RE: Proposed Arkell Development – Response to NPG Planning Solutions (June 19, 2026)
605 Arkell Road and Part of Lots 7, 8, 9
Concession 10
Township of Puslinch
County of Wellington

**RE : Responses to Peer Review Comments for Arkell Subdivision, South of Arkell
Road and East of Watson Road South, Puslinch, ON
HGC Project #: 02600117**

**Re: ZBA 3rd Formal Submission
Arkell Subdivision
Puslinch, ON**

RE: **NPG Comments**
605 Arkell Road & Part of Lots 7,8,9, and Concession 10
RE: Application for Zoning By-law Amendment – 1st Technical Review

Conceptual Plan 44 Lots

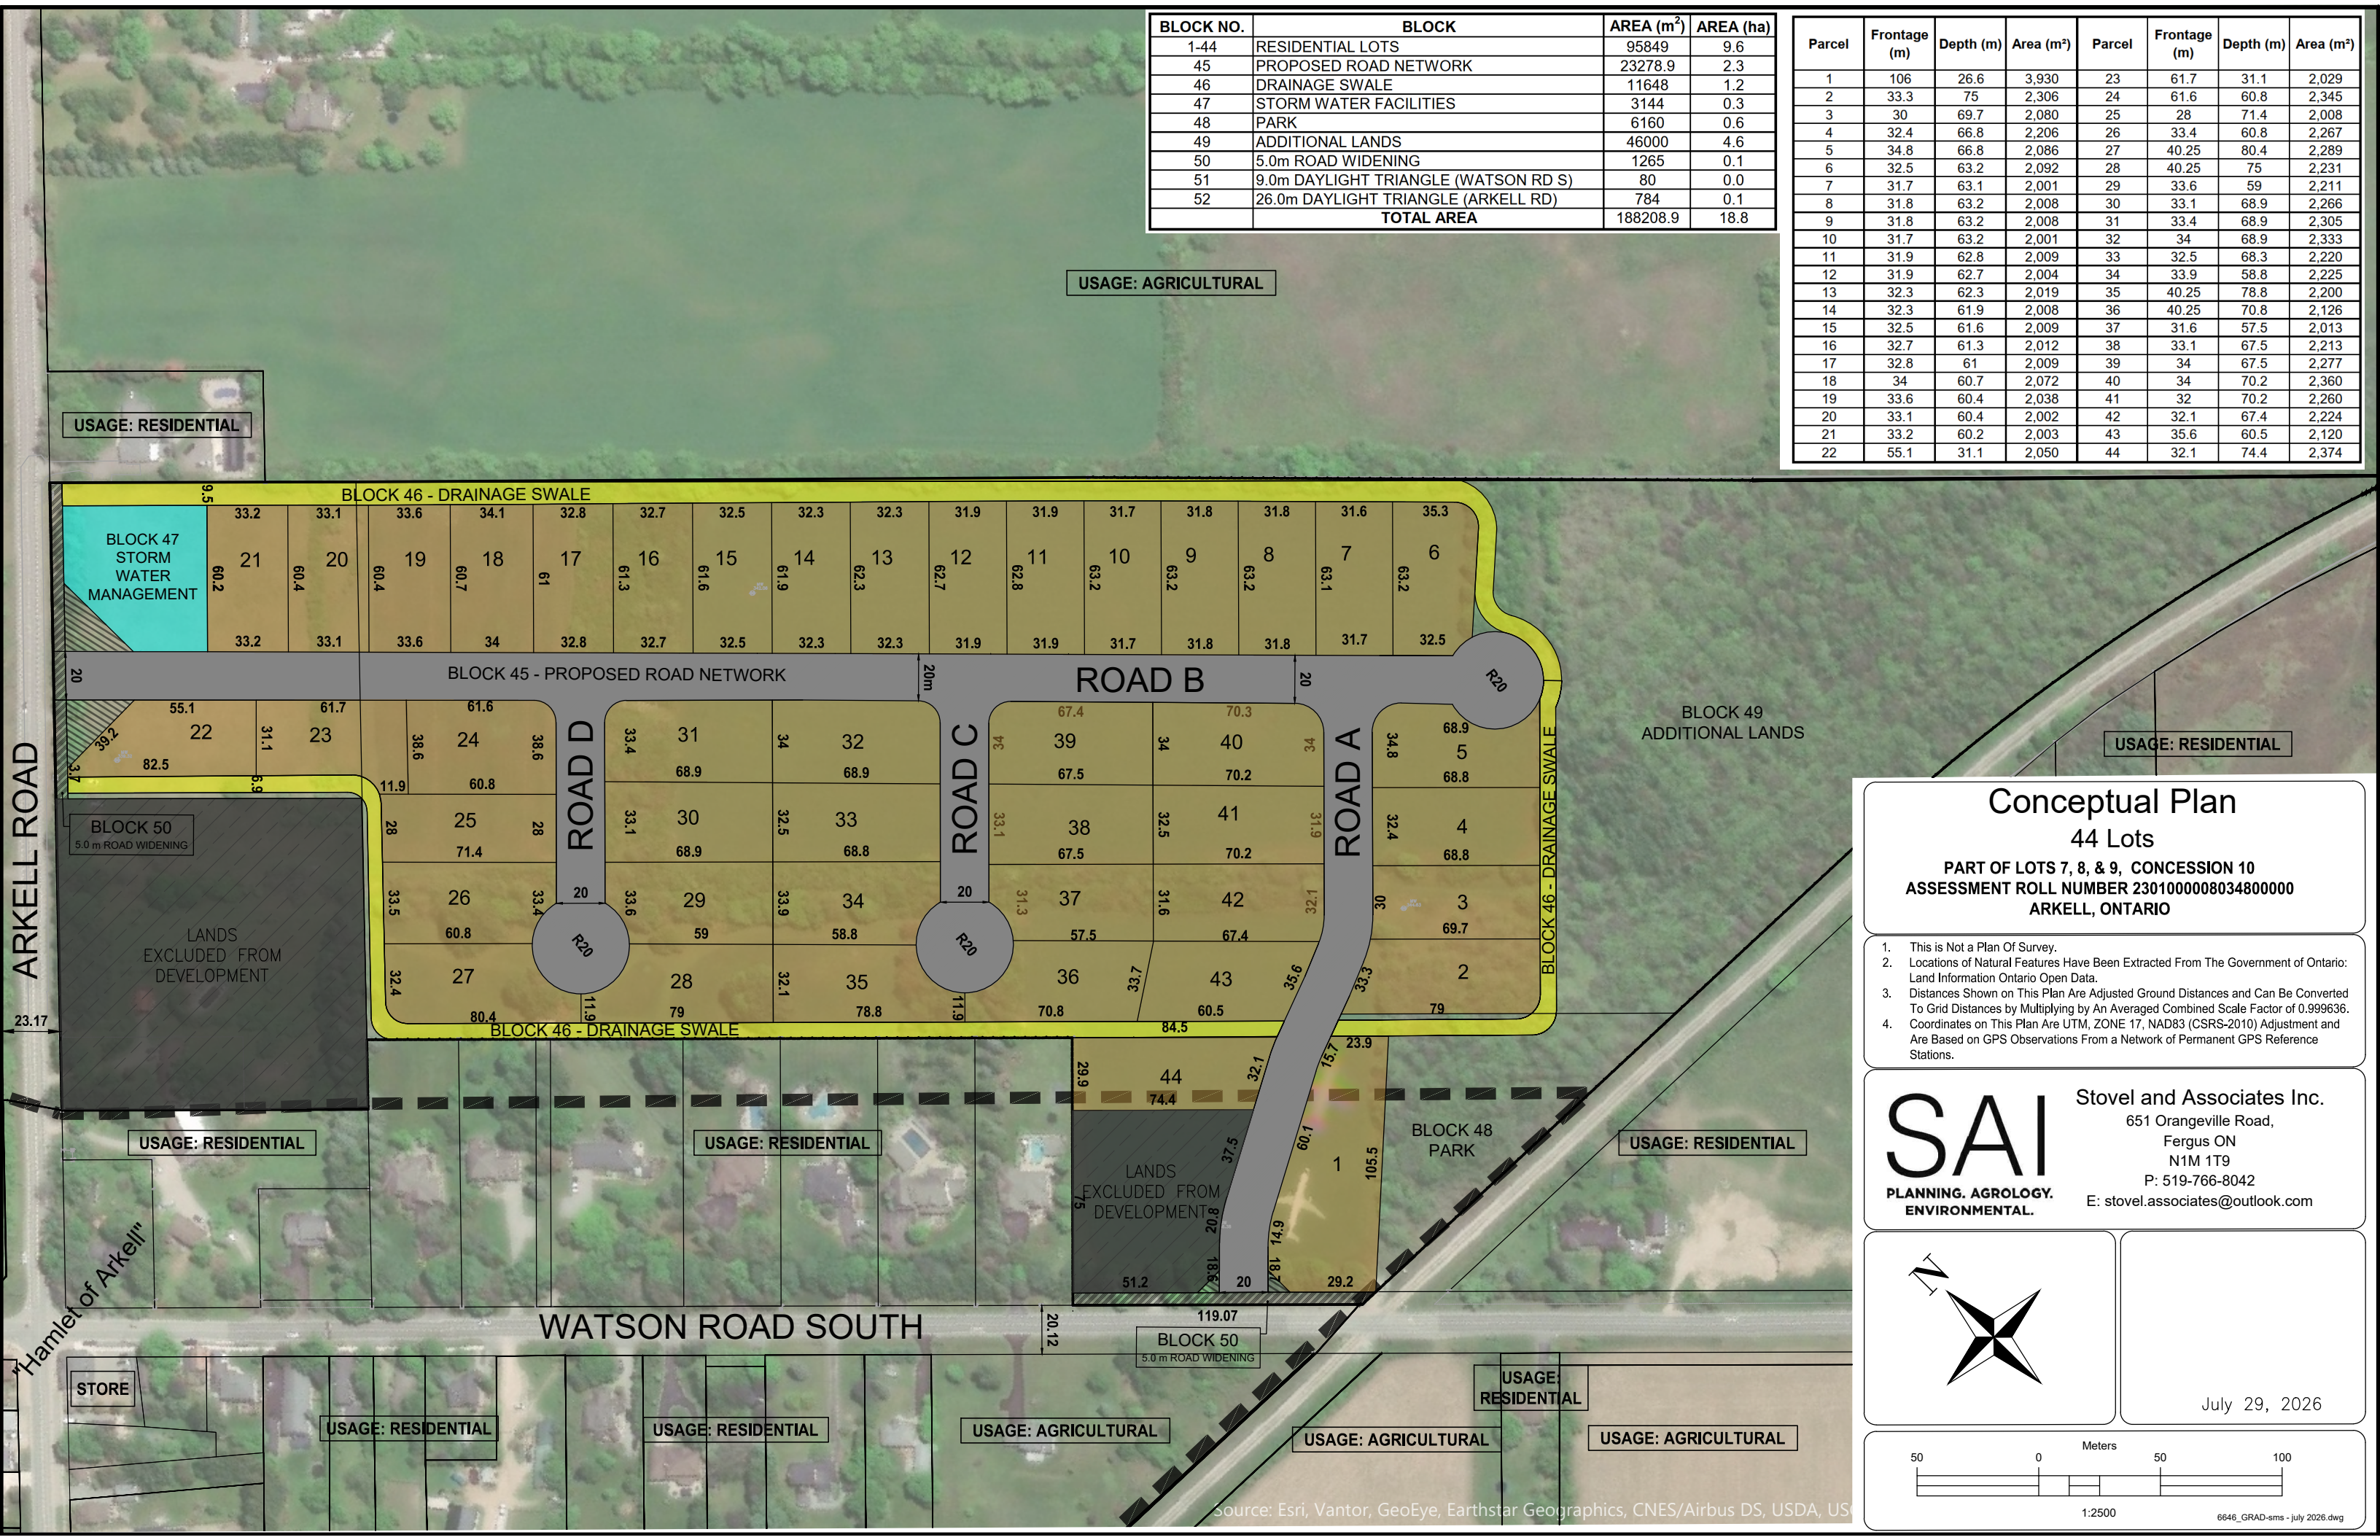
3. g) Concept Plan clarification.	Detailed comments regarding Blocks 46-49, the retained portion of 605 Arkell and lands immediately south of Block 44. The Concept Plan should demonstrate the current uses of adjacent lands and the width of abutting Roads.	Items i) – iii) inclusive will be addressed at the Draft Plan of Subdivision Stage. The Concept Plan has been revised to show the current uses of adjacent lands and width of abutting roads.	See attached the revised Concept Plan.

Clarify the use of the strip of lands immediately abutting Watson Road South. The Concept Plan may need to be updated (additional comments on EIS and Noise Study). 4.26.1 of the ZB prohibits grading or landscaping (exceeding 0.6 m) within sight triangles. The sight triangle is 46 m	The strip of land immediately abutting Watson Road South is intended to accommodate an anticipated future road widening. The precise width and extent of the road widening will be determined through the Draft Plan of Subdivision process in consultation with the applicable road authority. The Concept Plan will be labelled accordingly. Understood. The Township Noise consultant is satisfied with the HGC submission. SAI requested input from Crozier on this matter. Crozier confirmed that a 46m sight triangle is not required.

- d. With respect to the concept plan, we offer the following comments:
 - i. It is noted that if blocks 46 and 48 become lots as part of the draft plan of subdivision application, these lots may not meet the minimum lot frontage requirement.

- ii. A 5-metre road widening has been identified along Watson Road South on the Concept Plan. Please include the current width and the original centreline of this right-of-way to confirm if any road widening would be required through the Draft Plan of Subdivision process.
